EEG-52

AN EVALUATION OF AIR EFFLUENT AND WORKPLACE RADIOACTIVITY MONITORING AT THE WASTE ISOLATION PILOT PLANT

William T. Bartlett

February 1993

Figure 3. Picture of Underground Exhaust Stack and Station A (view is to the northeast)

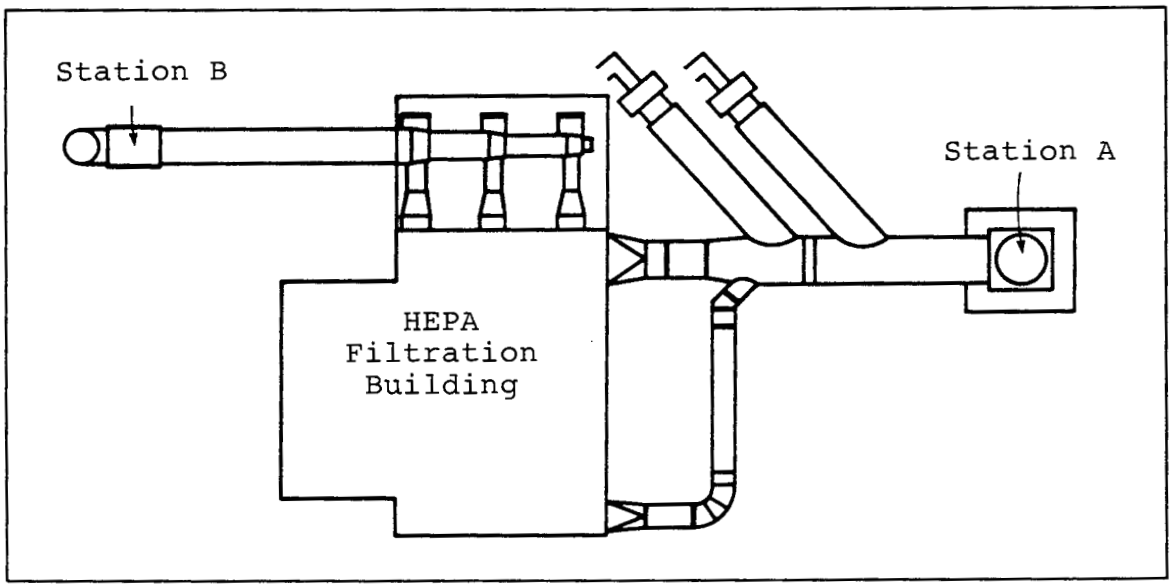
At the WIPP, there are two stacks, approximately 10 meters in height, which discharge at a 45° angle to the ground horizon (see Figure 3). This design is not optimum for dispersing and diluting effluent. The traditional design, a vertical stack, is assumed in the CAP-88 code programming. The code also allows for an area or ground release. Because of the unusual WIPP stack design, the Stoller report calculations assume an effective stack height based on the stack angle. The vertical stack modeling methodology is used in lieu of an angular method.

In addition to ground release corrections, building wake effects must be considered. As shown in Figure 3, the HEPA filtration building is located approximately 8.5 meters from, and in direct line with, the horizontal releases from the underground exhaust stack. The HEPA filtration building roof is at approximately the same elevation as the lower portion of the rectangular exhaust stack aperture. As situated, the exhaust stack is in the SE quadrant of the facility secured area. The prevailing horizontal exhaust direction will cross diagonally through key on-site building locations. Backwash and fumigation conditions would likely occur in areas occupied by on-site personnel. This scenario was presented to the DOE at the February 1991 Quarterly Meeting. The DOE has not responded, and there apparently are no empirical data to verify exhaust effluent patterns.

(4) The on-site dose calculation codes should be revised to include backwash and building wake effects. In the event calculation codes can not be appropriately revised and certified, then stack-related empirical corrections factors should be experimentally derived for use in on-site and off-site plume dispersion calculations. This information is essential to establishing effluent CAM alarm levels.

Figure 8. CAM 121/122 at S1600 and E300

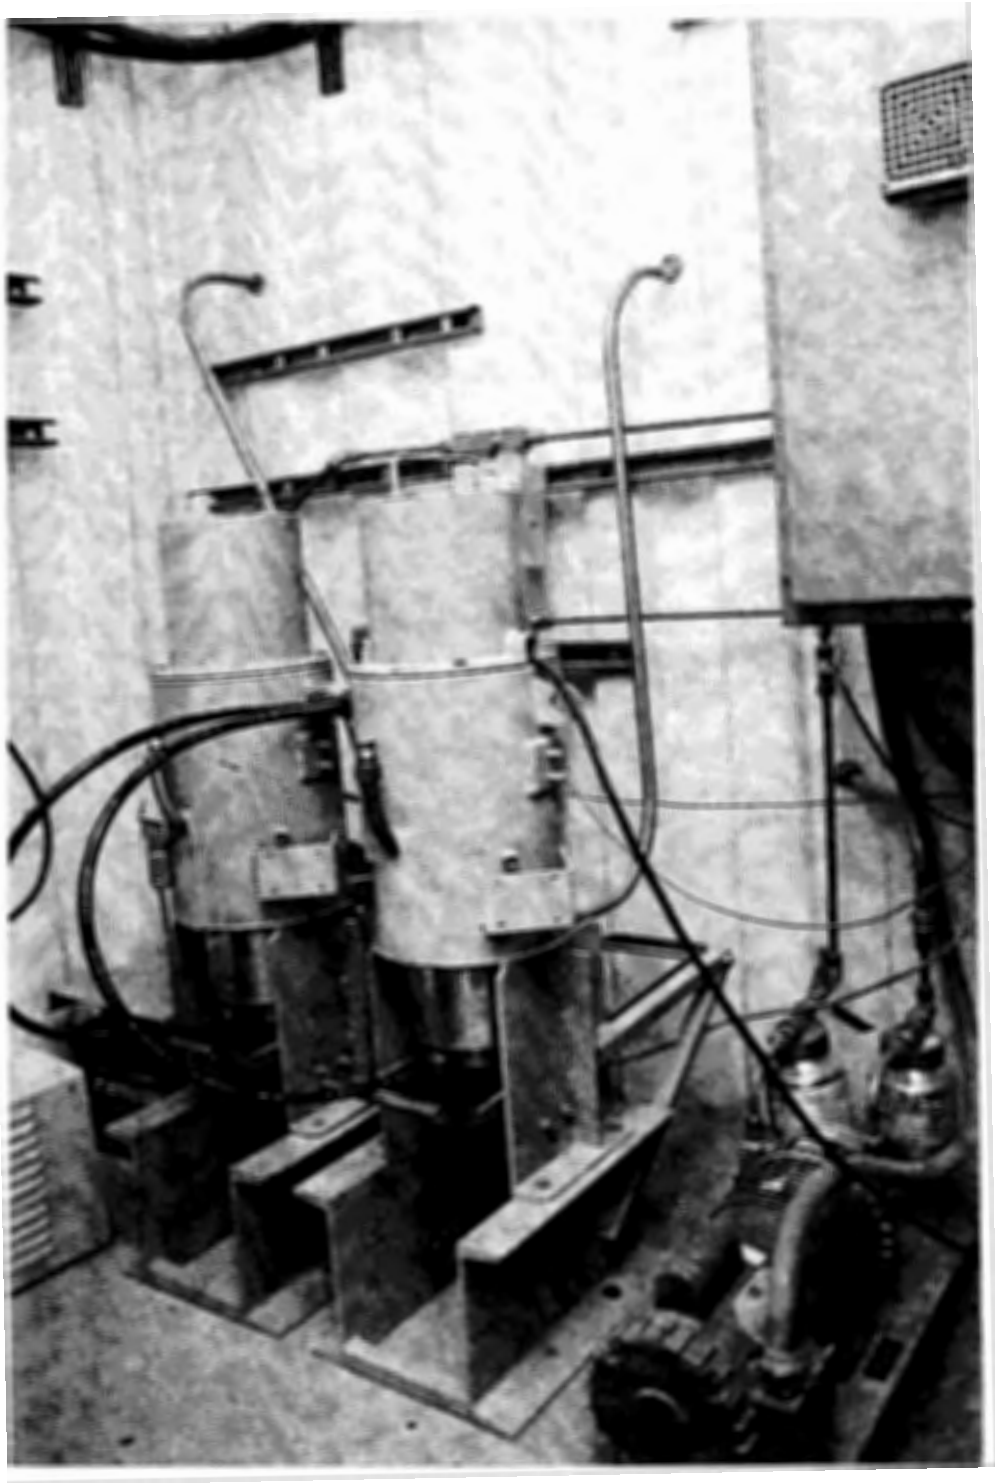
On September 12, 1992, EEG staff found both Station A alpha CAM systems red-tagged. The red tag normally indicates that equipment should not be used. The DOE stated that the red tag was placed on the equipment in January 1992 because out-of-specification detector/filter spacers were being used.

Figure 9. CAM 121 Sample Line Penetration at S1600 and E300

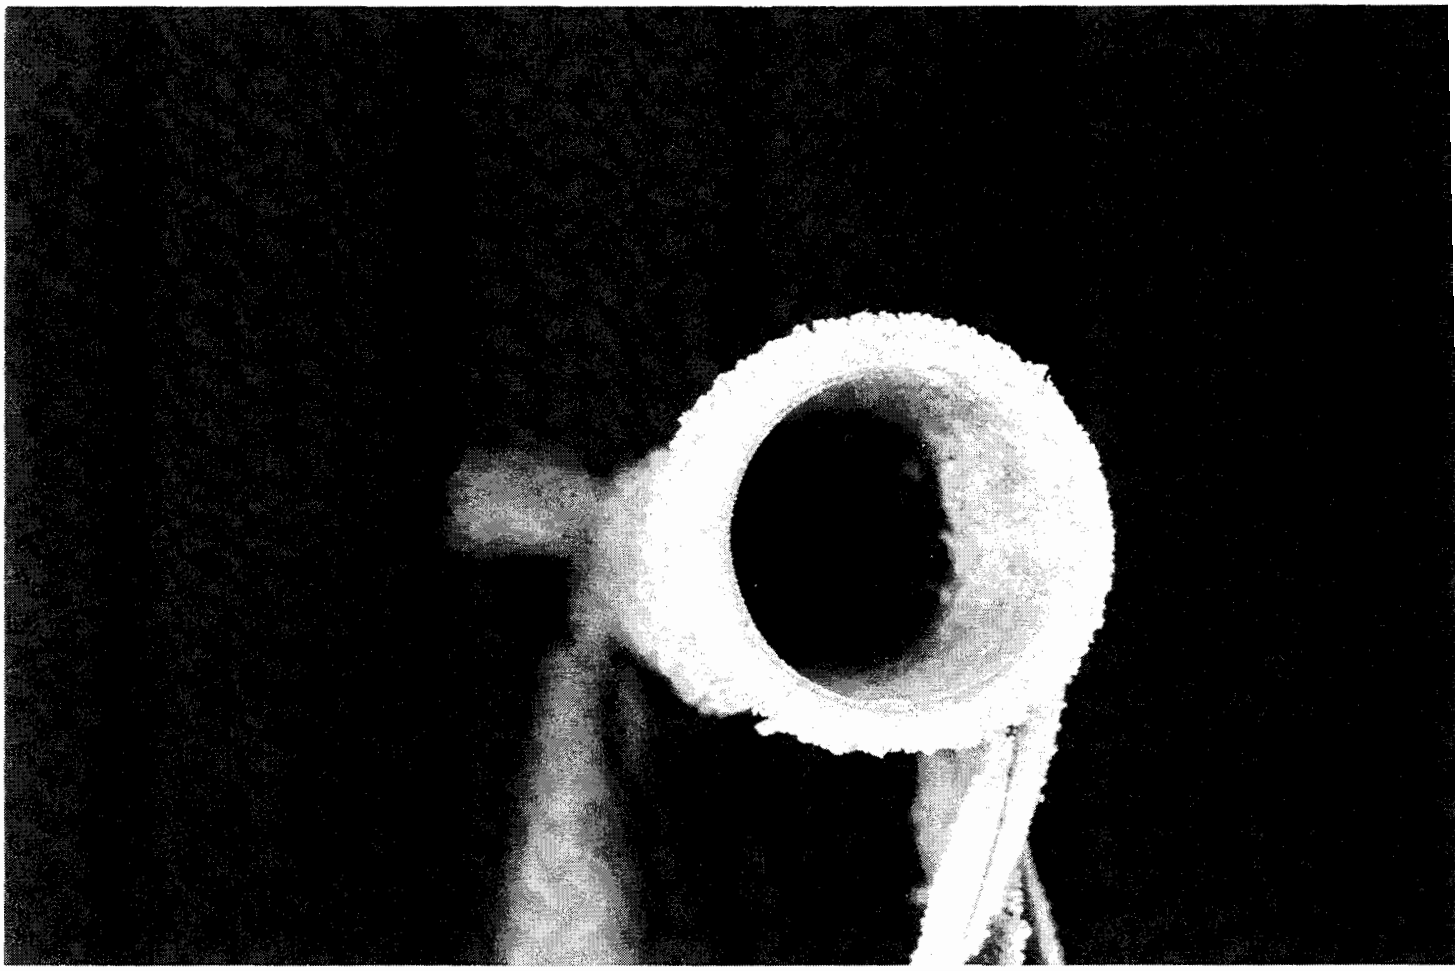
The Figure 9 photograph was taken on September 11, 1992 and shows one of the sample line penetrations into the E300 drift by CAM 121 pictured in Figure 8. There is significant salt buildup on the outside and inside of the sample line. The other sample line had similar salt buildup.

Figure 10. CAM 127/128 Station D Sampling Probe

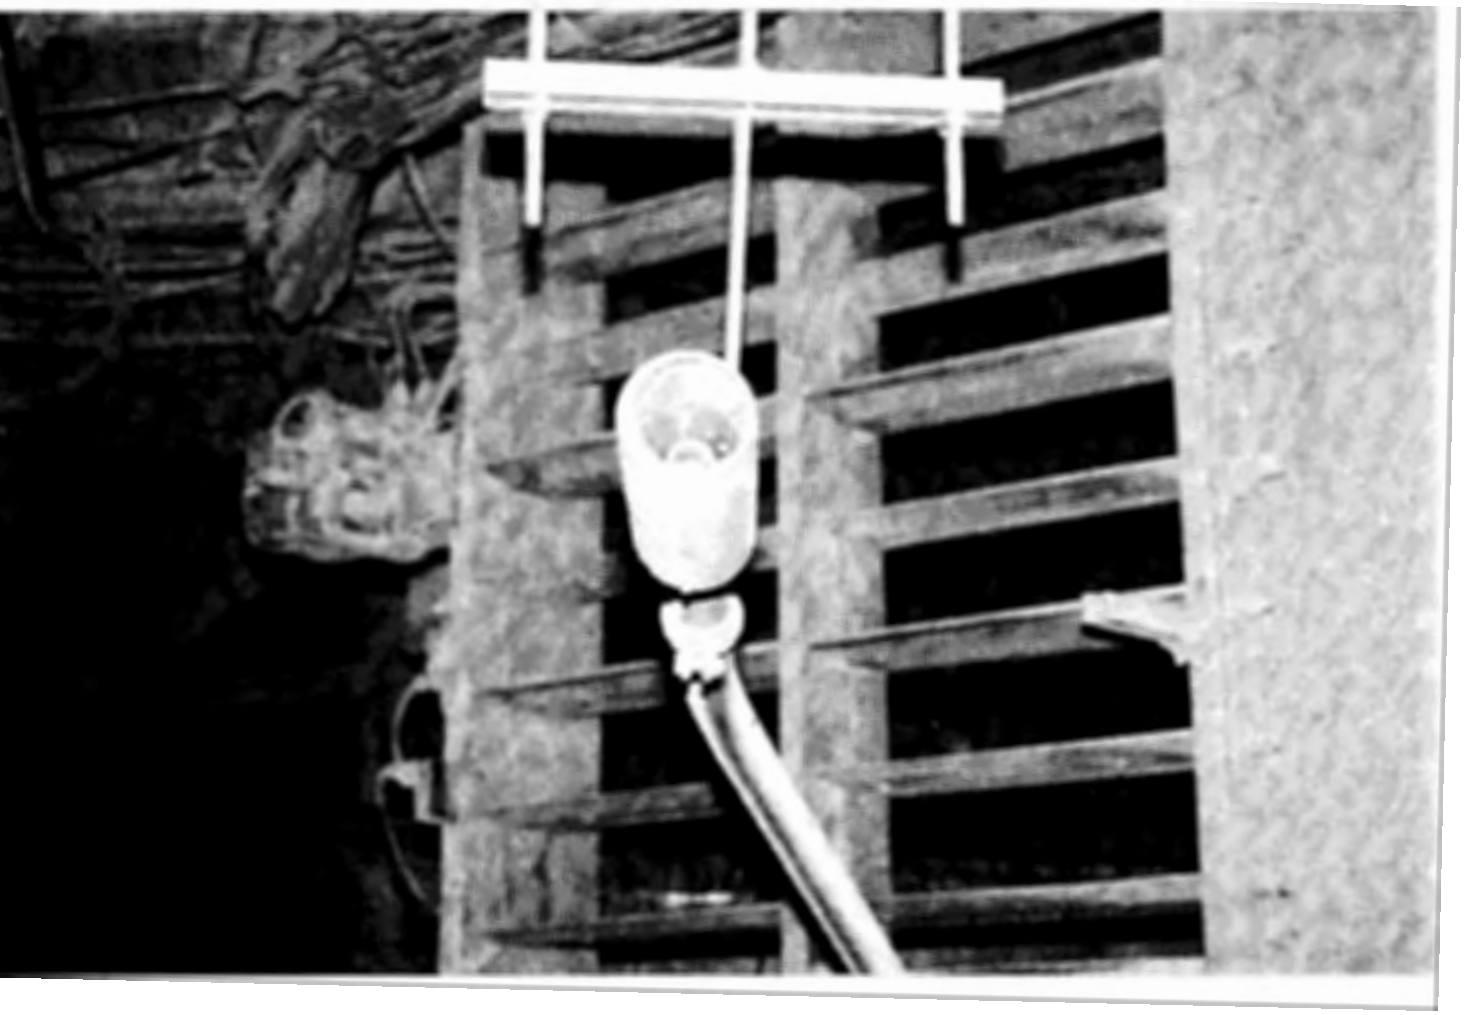
Figure 10 shows one of the Texas A&M modified probes at Station D with approximately 16 mm buildup of salt. The EEG provided an expert report (Neill 1989b) from the Southern Research Institute which suggested that as little as 5 mm salt buildup on the shroud would result in unacceptable shroud performance.

Figure 13. CAM Data Availability

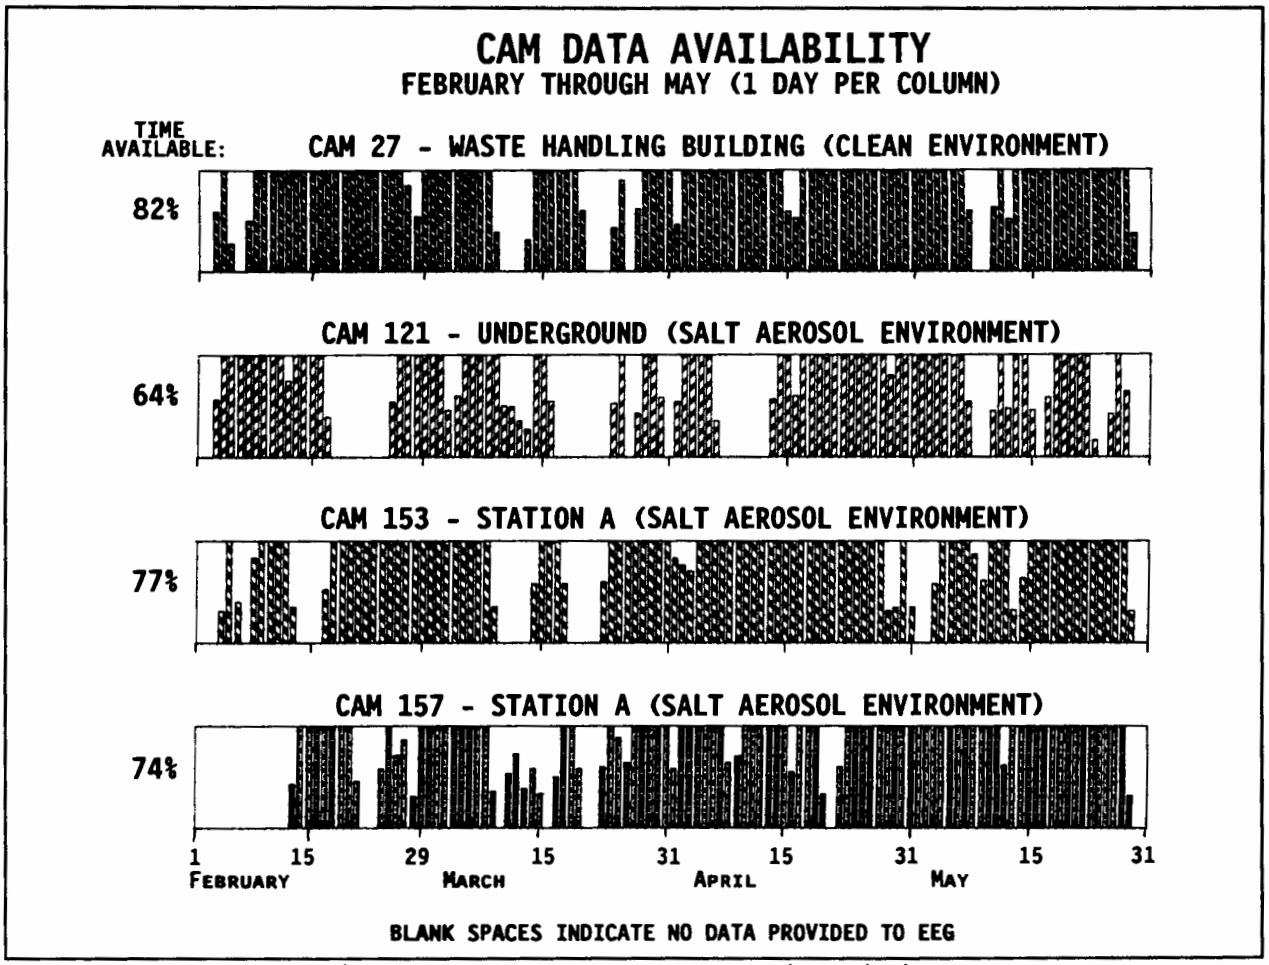
Figure 13 is a bar graph indicating the availability of CAM data from February to June 1992. Each bar on the chart represents a single day's data. Blank regions indicate days or portions of days when data were not available.

The DOE has not been able to provide specific reasons for lack of data, but general statements have been made that no data could mean that the computer archiving may have failed, plant power outages may have occurred, maintenance activities required interruptions, or possibly detector/equipment failures.

Figure 19. Degraded Spectra on High Salt Aerosol Day

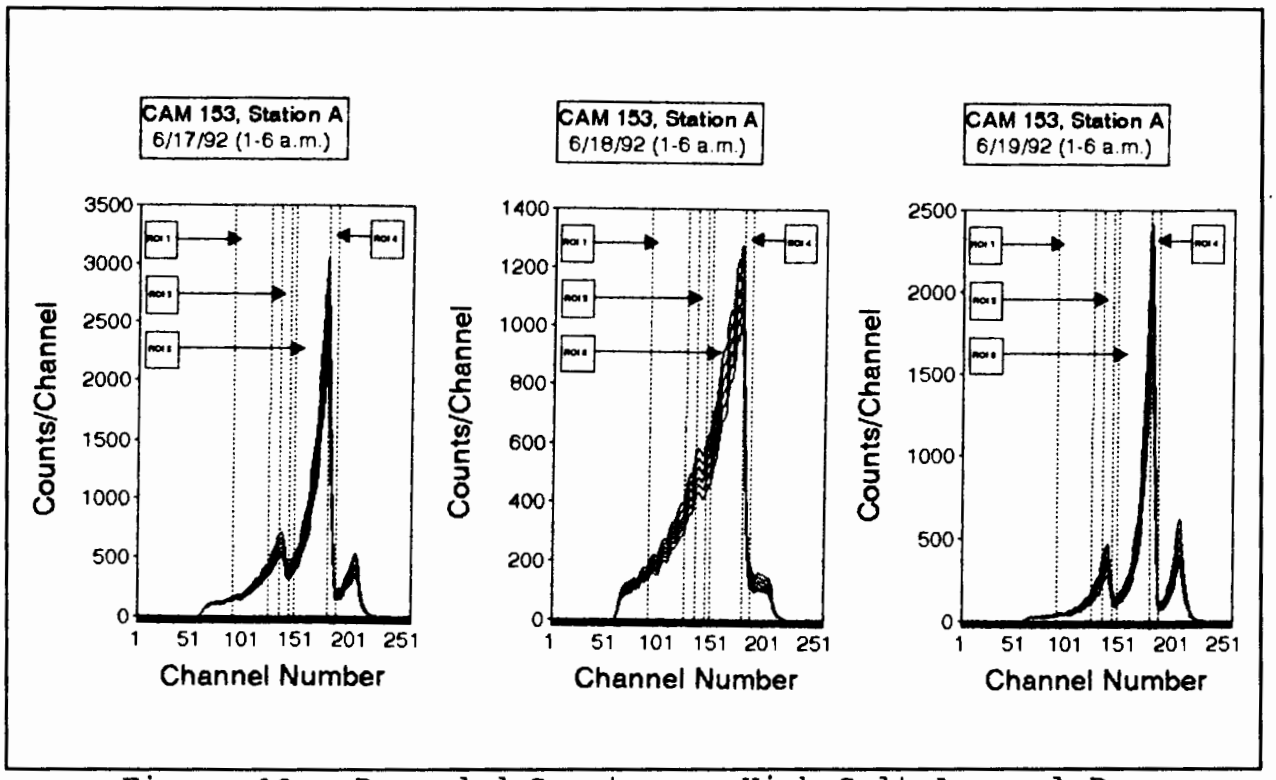
High filter salt loading can cause degraded spectra and negative plutonium channel counts. CAM 157 and 153 spectra were selected from 6/18/92 when filter salt loading was abnormally high (0.39 mg/m^3), and the spectra were significantly degraded (Figure 19 and Appendix F-15). On 6/17 and 6/19, the salt loading was much lower (0.011 and 0.070 mg/m^3, respectively), and the spectra were relatively good. The spectra on 6/18 are particularly revealing because both CAM 153 and 157 spectra are similarly degraded, and on the days before and after 6/18, spectra are reasonably good.

During the first six hours of 6/18, the CAM 153 plutonium channel count average was a negative 12 CPM. During this same time

Figure 20. Effective CAM-153 Alarm

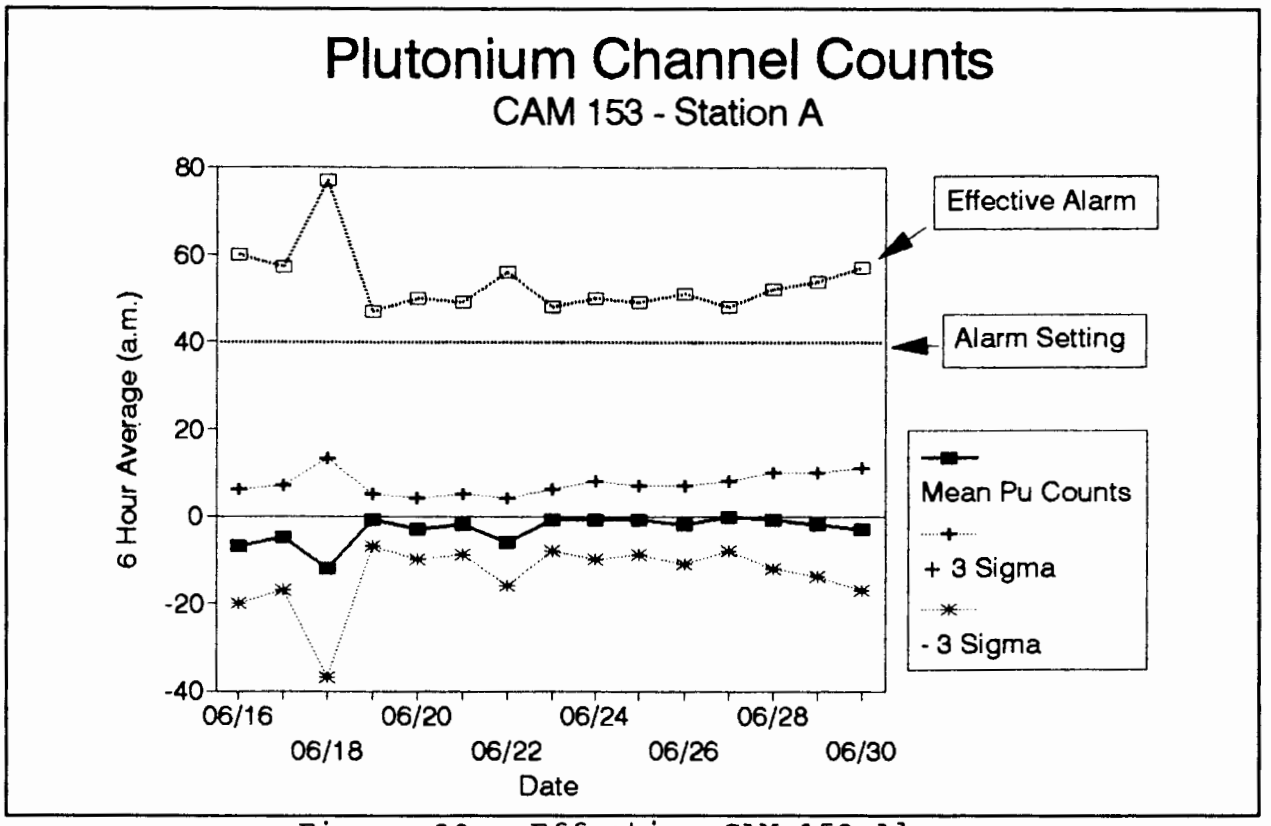
When plutonium channel counts are negative, the effective alarm level is increased. The stated WIPP effluent alarm level is 40 CPM, but Figure 20 data indicate that the effective alarm level is higher than 40 CPM when negative excursions and range variations are considered. When errors caused by the wide range of allowed detector efficiencies, reproducibility of the measurements, or other system errors are considered, the effective alarm level may be much higher than the actual setting.

Figure 21. Comparison of CAM Count Rates with One Detector Malfunctioning

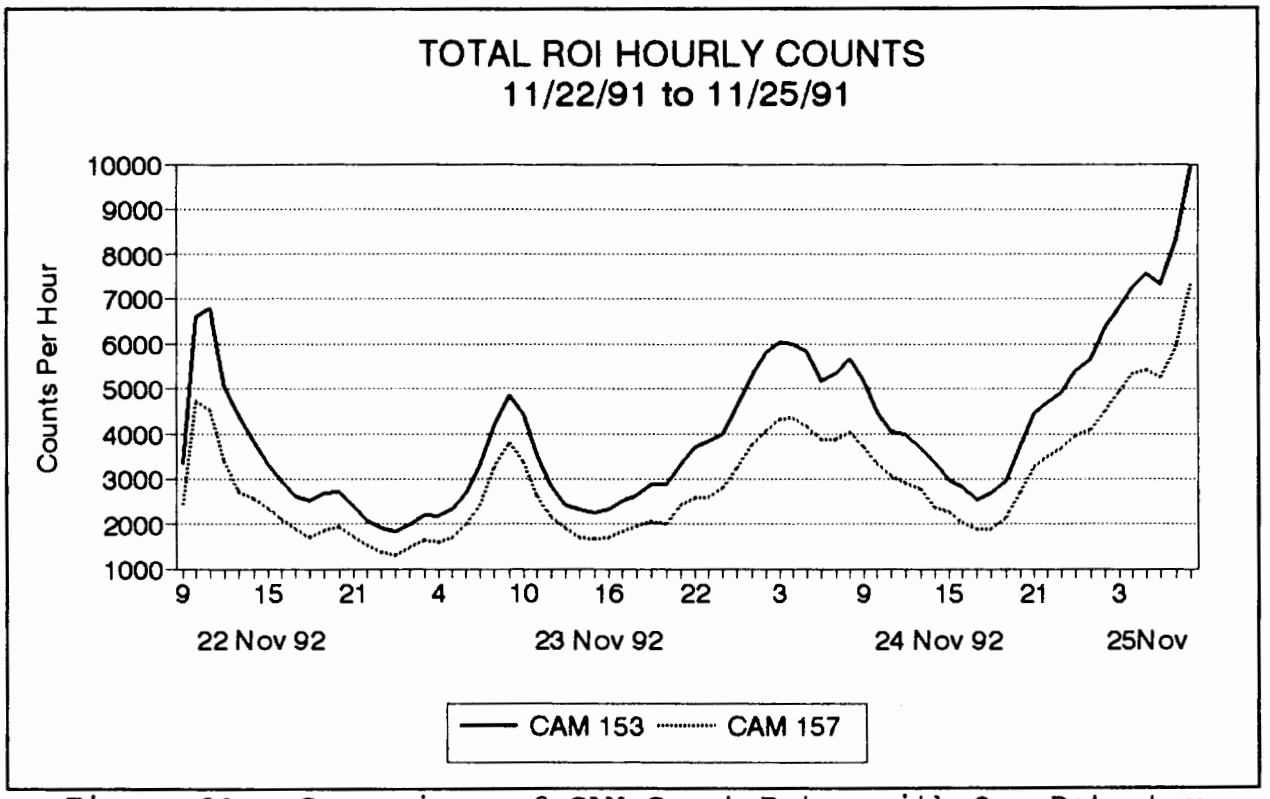
In the first example (11/22/91 to 11/25/91), the CAM 157 detector was non-operable as evidenced by the degraded spectra (Appendix F-21). A graph of counts in all four ROIs (Figure 21) indicates the CAM 157 detector efficiency was about 30% less than CAM 153. Graphs of each ROI count rate (Appendix F-22) indicate that ROI 3 and 4 relative efficiencies vary significantly. The change in relative detector efficiency was expected, but plutonium channel minute-by-minute counts do not indicate a detector efficiency problem (Appendix F-23 and F-24).
